Model	Model Code	Model Type
BF175AK2	BAJJ,BAKJ	
BF200AK2	BAEJ,BAFJ	
BF225AK2	BAGJ,BAHJ	
BF250A	BBJJ

Authorized by MATSUMURA HIROYUKI
Power Product Service Engineering Department, Honda Motor Co.,Ltd

6AH2012048-00

Broken Propeller Shaft

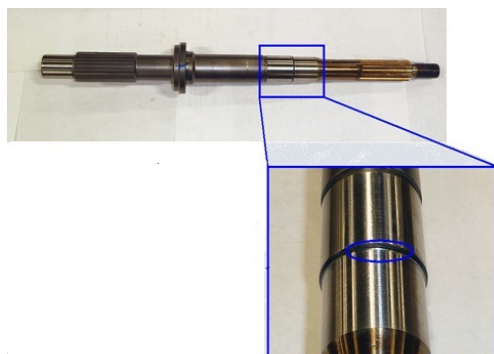
While driving the boat the engine lost forward thrust and the engine speed quickly went to the rev limiter. Propeller shaft was fractured.

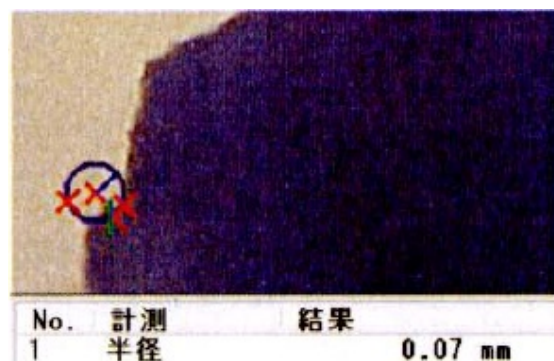
1. Propeller shaft concentrate stress during operation due to propeller shaft radius section was not polishing properly.

Claim propeller shaft radius section is 0.07mm

Drawing specification is 2.0mm

Supplier change grind stone shape at propeller shaft polishing process for maintain proper radius section on shaft.

Texas flat boat image

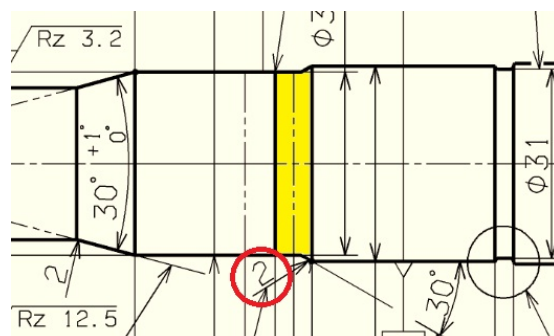
2. Customer used Texas flat boat which is specially developed for very shallow water level. During Operation cyclic loading applied to propeller shaft from the propeller due to propeller was not fully submerged.
